Project	<b>IEEE 802.16 Broadband Wireless Access Working Group</b> < <a href="http://iee802.org/16">http://iee802.org/16</a> >	
Title	<b>IEEE 802.16e HO options for forcing and suggesting HO</b>	
Date Submitted	<b>2003-09-04</b>	
Source(s)	Sungjin Lee, Jungje Son Changhoi Koo  Samsung Electronic, Suwon P.O.Box 105, 416, Maetan-3dong, Paldal-gu, Suwon-si, Gyeonggi-do, Korea 442-742	Voice: 82-31- 279-5091 Fax: 82-31- 279-5130 <a href="mailto:steve.lee@samsung.com">steve.lee@samsung.com</a> <a href="mailto:jungje.son@samsung.com">jungje.son@samsung.com</a> <a href="mailto:chkoo@samsung.com">chkoo@samsung.com</a>
Re:	The contribution corresponding to commentary 109 sub-item 3	
Abstract	This contribution is to provide an option of forcing handoff or suggesting handoff, and option for the MSS to reject a suggestion. And this contribution is an answer for commentary 109 which had been discussed in the last meeting.

# IEEE 802.16e HO options for forcing and suggesting HO

Fig1. Scenario of MSS turns back movement case

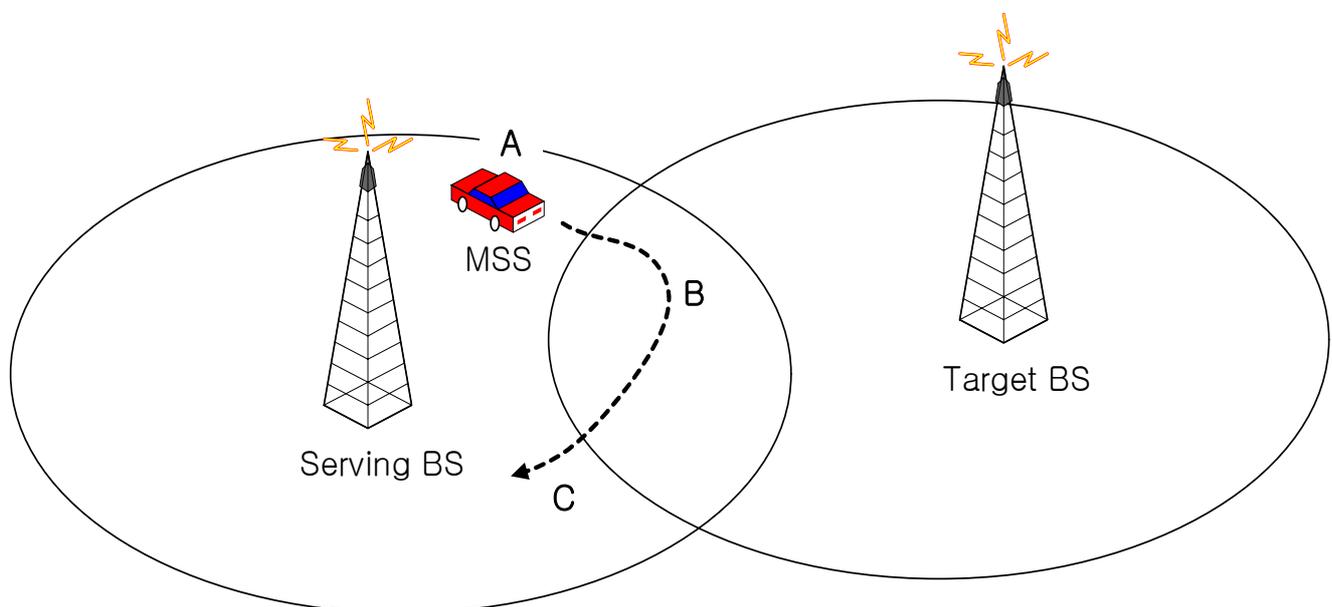
In figure 1, the MSS decided to trigger HO process when arrives at the location A so that it starts scanning neighbor BSs after exchanging MOB\_MOB\_REQ and MOB\_SCN\_RSP messages with serving BS. At the next step the MSS arrives at B location and send MOB\_HO\_REQ message to Serving BS and wait until it receives MOB\_HO\_RSP message from Serving BS including Target BS information that is gathered from HO\_notifications and response HO procedure. The Serving BS exchanges HO\_notification

and response messages with Target BSs and then send the MOB\_HO\_RSP message toward MSS in the cell. At this time, the MSS moves back to location C and recognize that it is not in the HO situation anymore. Since there could be many cases that is needed to stop or cancel HO procedure depends on the situation changes, although the HO process is already started. In order to provide the functionality of HO cancellation in the HO condition changes such as scenario described in Fig 1, we propose cancellation option using extended MOB\_HO\_IND message in current HO AdHoc draft document. We also propose reject option in addition to cancel option in order to provide reject functionality for MSS to reject the unsatisfied contents and parameters that are included in MOB\_HO\_RSP message.

**Figure D.4 – HO cancellation before HO notification-confirm**

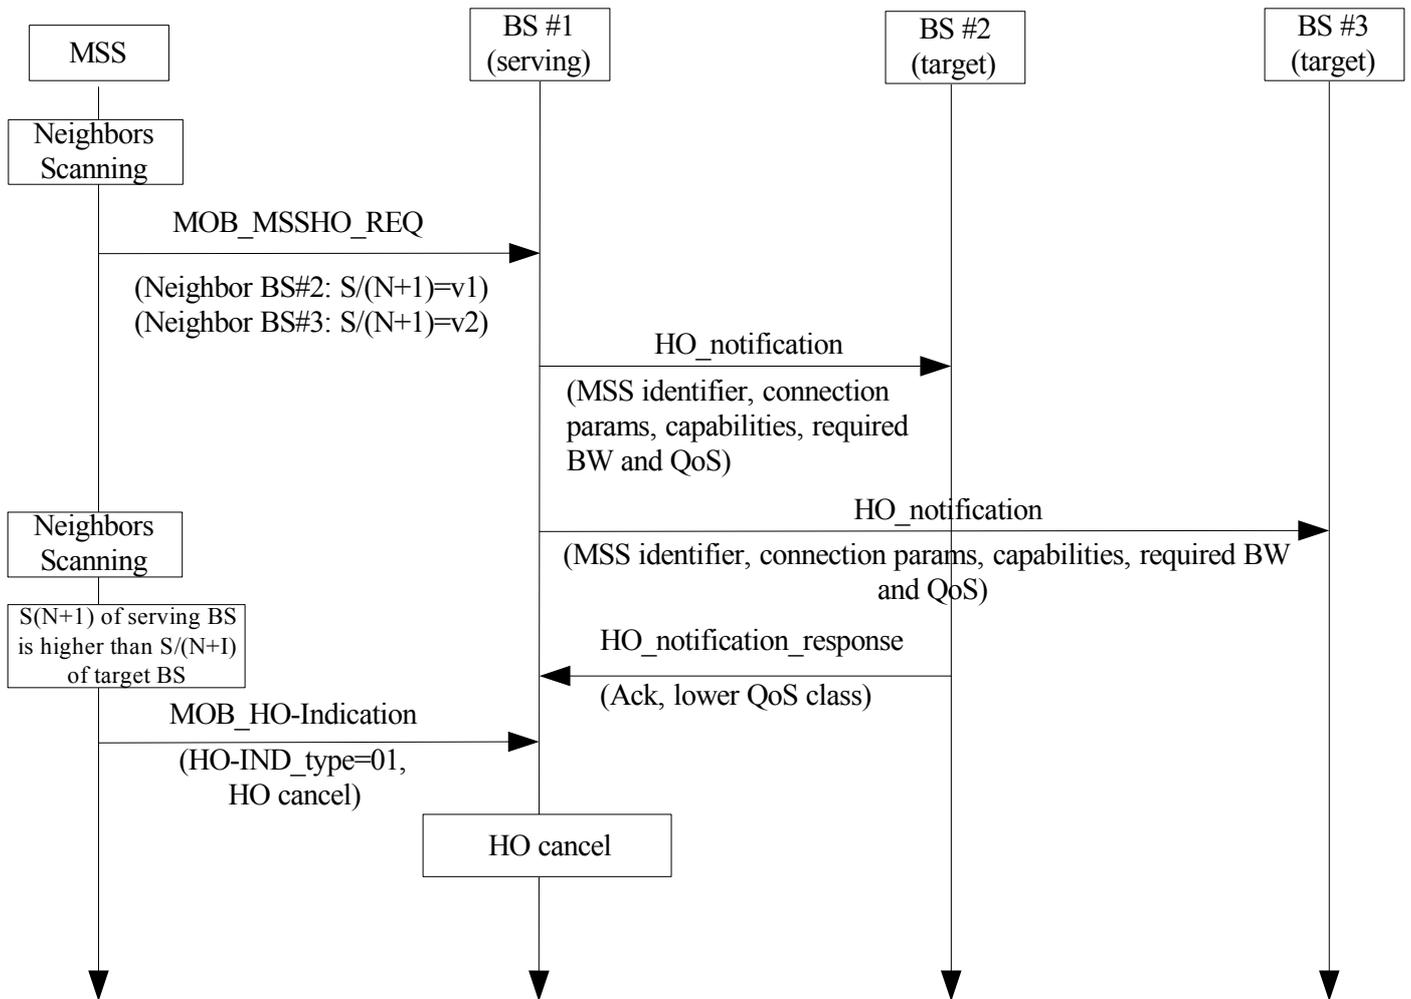
After the MSS or BS initiate HO, the MSS can cancel the HO at any time if the MSS is still connected to the serving BS and as far as the HO is not completed yet. The MSS cancel the HO by transmitting the MOB\_HO\_IND message with the HO\_cancel option (HO\_Type=01)

**Figure D.5 – HO cancellation after HO notification-confirm**

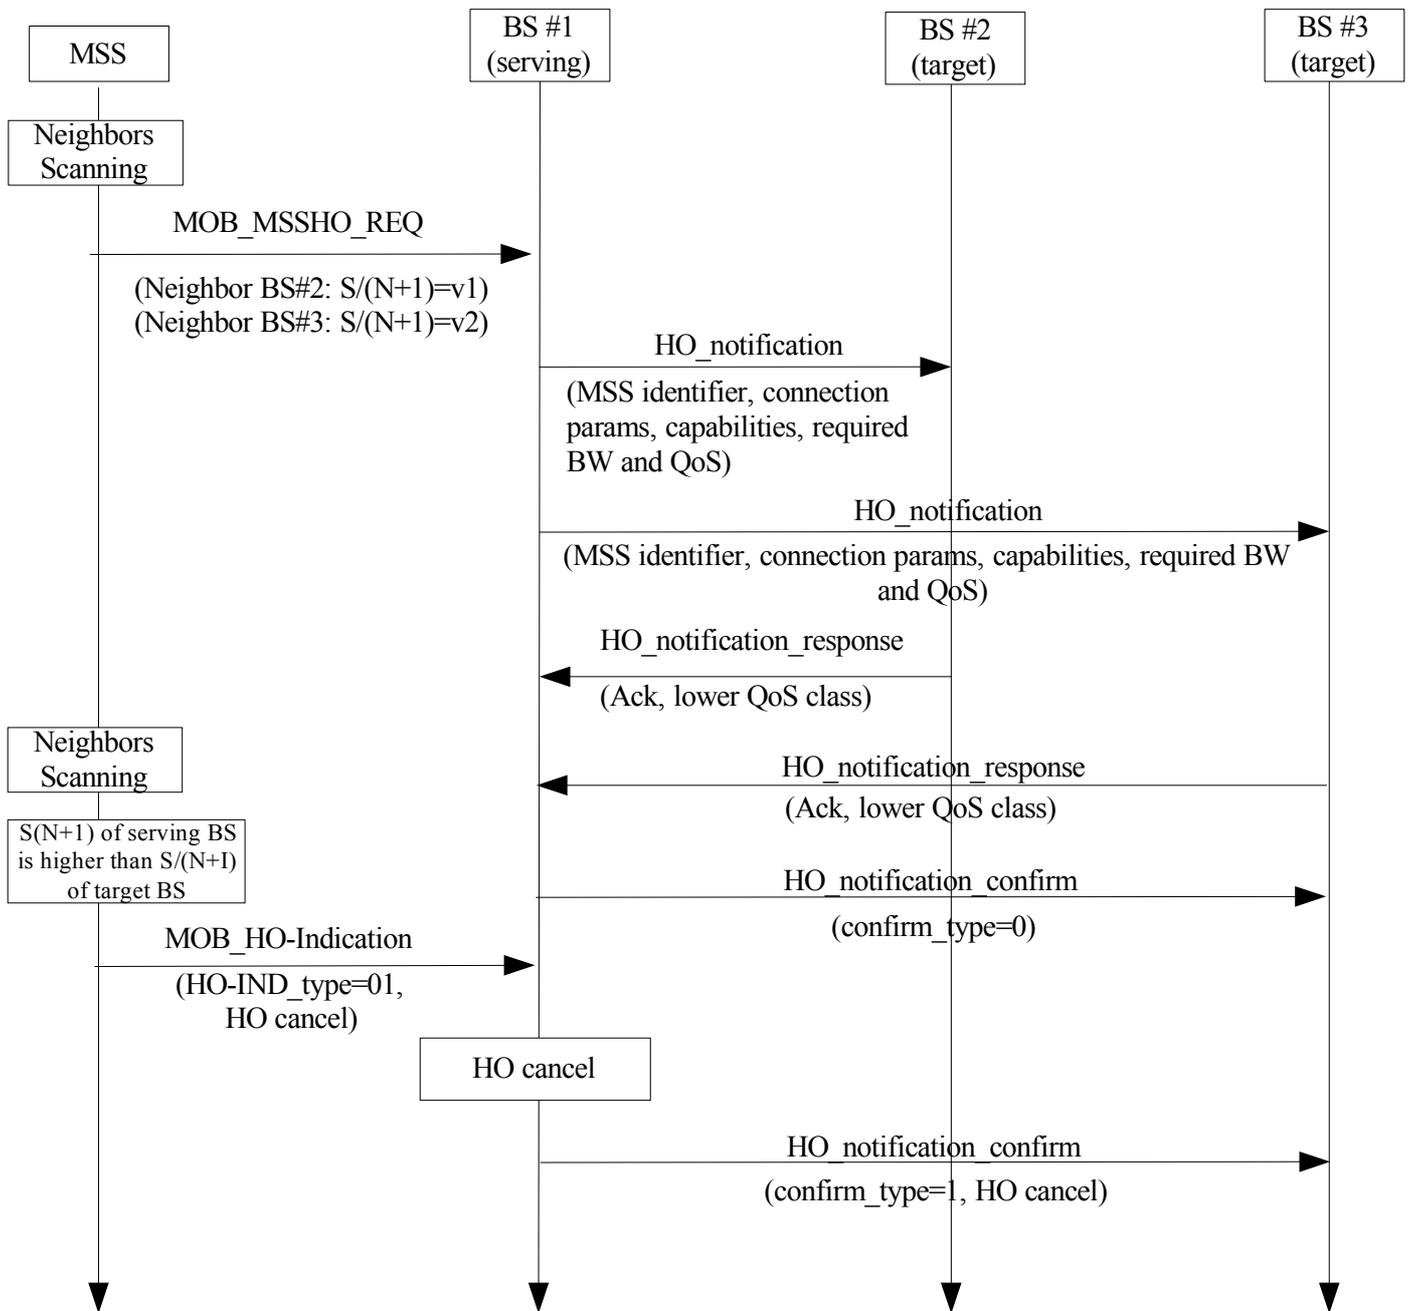
If confirmation\_type field is set to '1' the HO\_notification-confirm message notify that the HO is cancelled. Therefore the target BS that is received this message does not wait until the handoff occurs. If the target BS reserved resources for the upcoming handoff, it should be released.
